UNITED STATES OF AMERICA  
NUCLEAR REGULATORY COMMISSION

MEETING WITH  
NRC STAFF AND  
PUBLIC SERVICE COMPANY OF NEW HAMPSHIRE

Thursday, April 9, 1987

16 MR. LONG: We distributed some corrected pages  
17 from the technical specifications that were issued with the  
18 fuel load and precriticality testing license. These are to  
19 be discussed today to see if the corrections are proper and  
20 to discuss any other items that have come up in the interim.

FIGURE 6.2-1  
OFFSITE ORGANIZATION

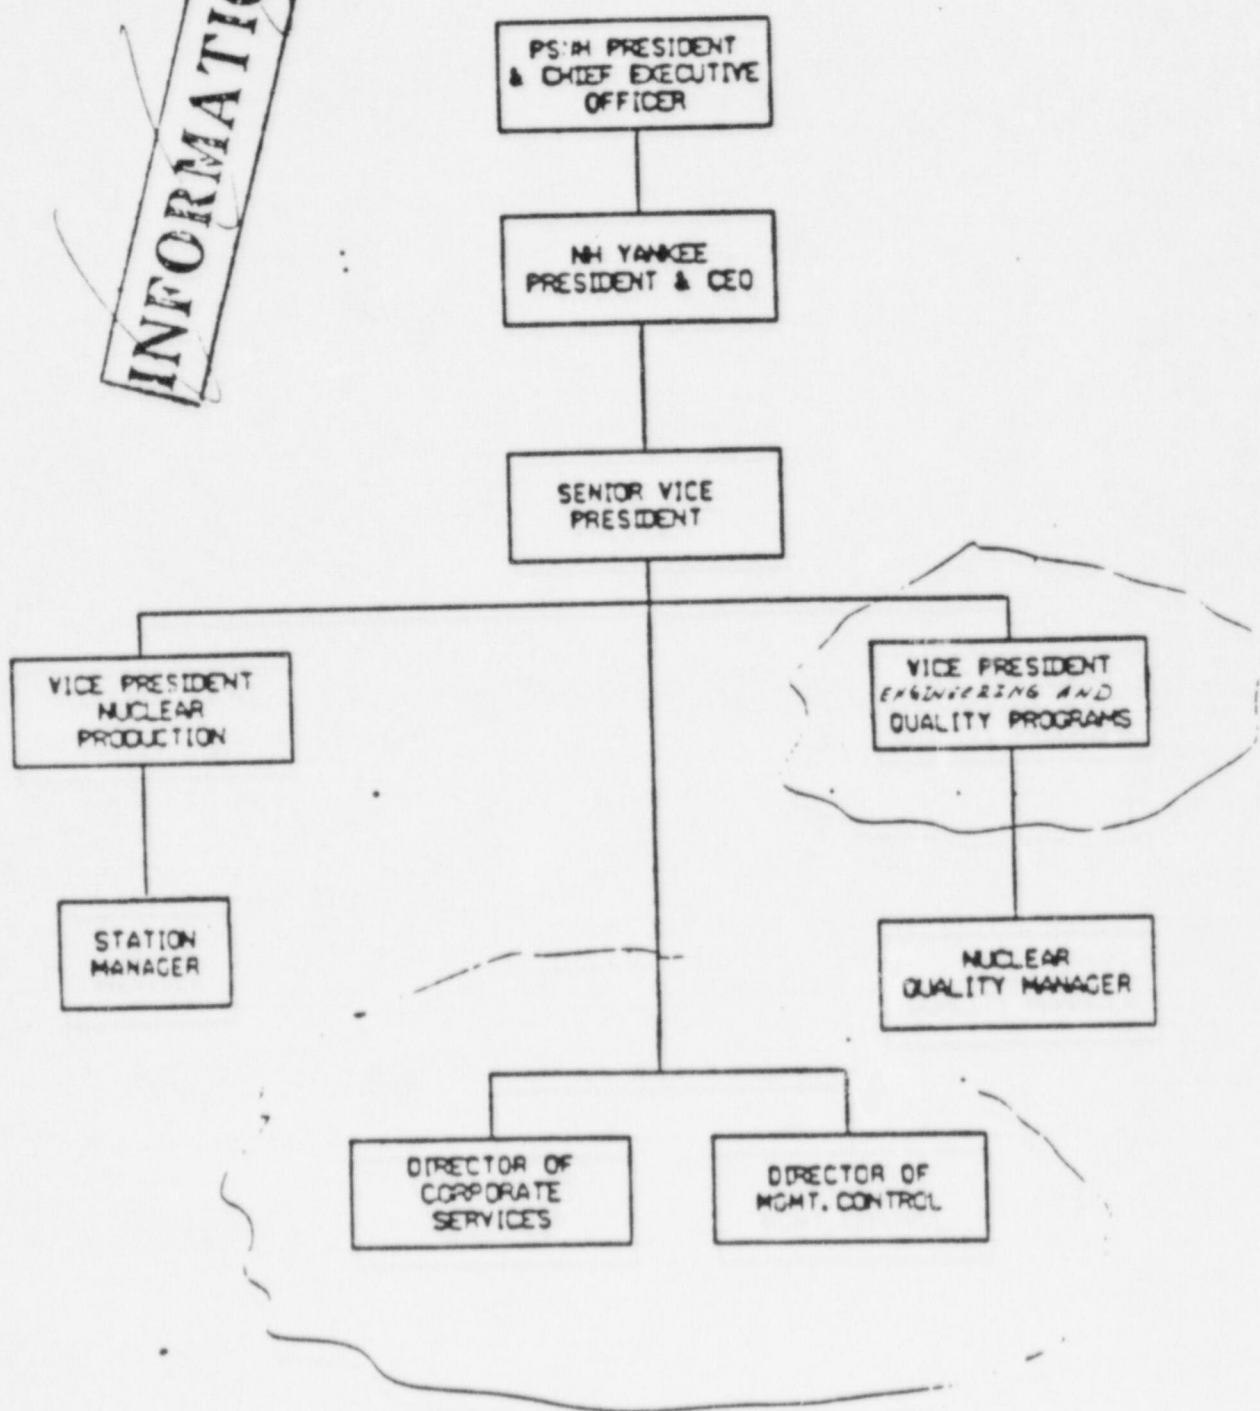
6 The next two pages in the package are the  
7 organization charts, and these were discussed at the meeting  
8 and provided in the letter.

10 MR. BELANGER: We will provide camera-ready copies  
11 of these.
